# ***Interactive comment on “Bromine Speciation in Volcanic Plumes: New in-situ Derivatization LC-MS Method for the Determination of Gaseous Hydrogen Bromide by Gas Diffusion Denuder Sampling” by Alexandra Gutmann et al.***

Received and published: 3 July 2021

**Fig. 1.** = Figure 4: Figure 4: Denuder results are plotted against Raschig results. The orthogonal distance regression model resulted in:  $y = 0.97 (\pm 0.10) * x + 0.18 (\pm 0.10)$  and a residual variance of 0.25.

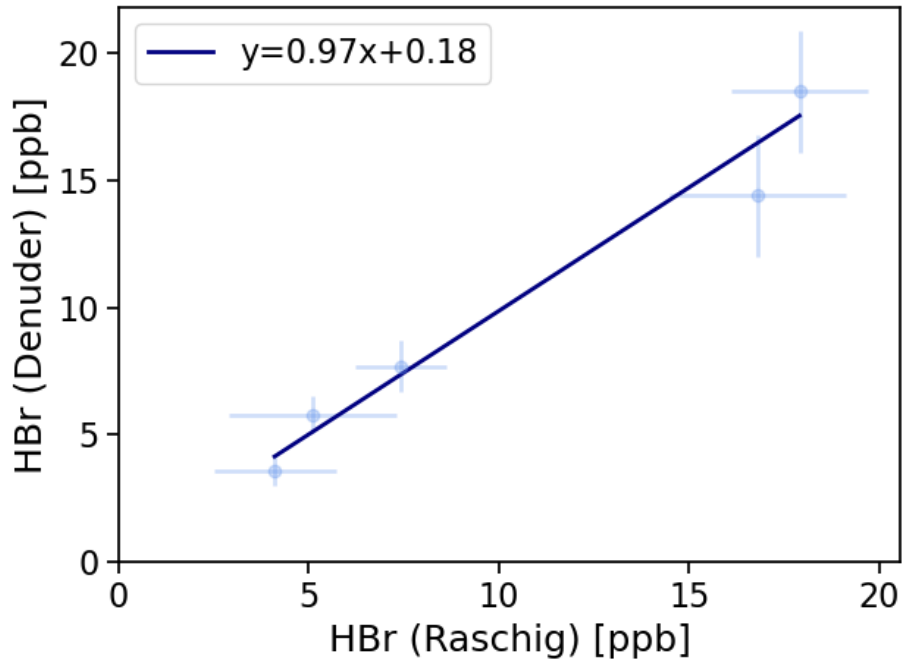
Reviewer: Figure 2: If the goal is to compare the two techniques using the Raschig Tube measurements as an independent variable in a calibration, an orthogonal distance regression of the two sets of measurements would more clearly demonstrate the comparability of the two sets of measurements and give the reader an idea of the sensitivity of the denuder measurements. As I point out above, the calibration should be performed over an atmospherically relevant range of values.

Response: Yes, the comparison with the approved alkaline method was used to prove the accuracy and, above all, the comparability of both methods, since a ratio is to be formed from their results.

We acknowledge the reviewer's comment about the need to discuss the comparison between the methods more thoroughly. We followed the suggestion to perform an orthogonal distance regression for comparing the results of both methods.

Changes: New Figure 4 (Fig. 1). On average, the results related to denuder sampling yielded  $99 \pm 11$  % of the HBr values determined by the Raschig Tube. An orthogonal distance regression was performed and is shown in Fig. 4. Based on the line equation obtained, small values, such as those observed here in the field samples, can yield higher results from denuder determinations than expected via the Raschig Tube. We have concluded, that the HBr values determined by denuders in field samples can be considered a fraction of the total bromine determined by the Raschig Tubes. To account for the comparison studied, the deviation found is included as an error of the denuder field samples in Table 4.

**Fig. 2.** = Figure 5: Fraction of HBr (determined by EP-coated denuders) to total bromine (determined by Raschig Tubes). Assuming a windspeed of 5 m/s, HBr fractions decrease on average from  $0.75 \pm 0.11$  at 0.7

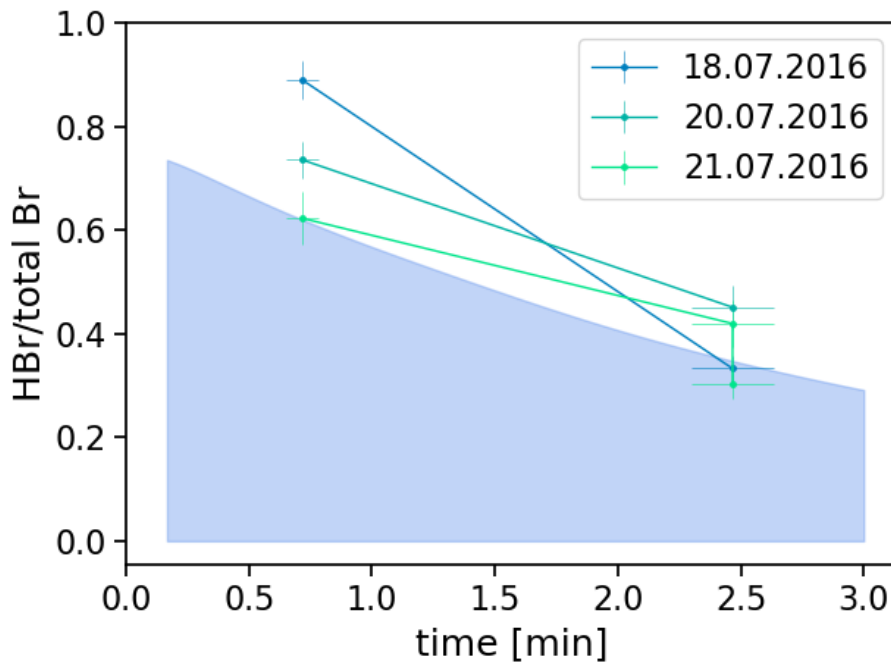
Reviewer: Line 282: Rephrase "This is in very good agreement with the results obtained with the model's estimations". The point of these comparisons is an evaluation of the model performance, not affirmation of your observations. The model being consistent with your observations reflects favorably on the model, but says nothing about the accuracy of your measurements as you imply here. This sentence as written implies you have doubts about the measurements. I would also add the model prediction to Fig. 5 for ease of comparison by the reader.

Reviewer: Fig. 5: As discussed previously, I think adding the model results referenced in the text would be helpful. The point markers should also be changed. Right now they can be confused with error bars, which is problematic. The author's should also add error bars on the ratio since they are presented in the caption. The y-axis label is not accurate. I believe what is being presented is the ratio of HBr/reactive bromine, not the ratio of HBr/ bromine atoms which is what the label says

Response: We agree with the reviewer's suggestions that the statements had to be rephrased. In addition, the model run mentioned was taken over into the figure

Response: We liked the suggestion to add the model run to the figure. It seems that the choice to add caps at the end of the error bars was confusing. They have now been removed to make the figure clearer. The y-axis labels have also been adjusted. What

can be seen here is the ratio of HBr to total bromine, which was labeled only as Br, misleading to bromine radicals. We changed to 'total Br' for clarification.
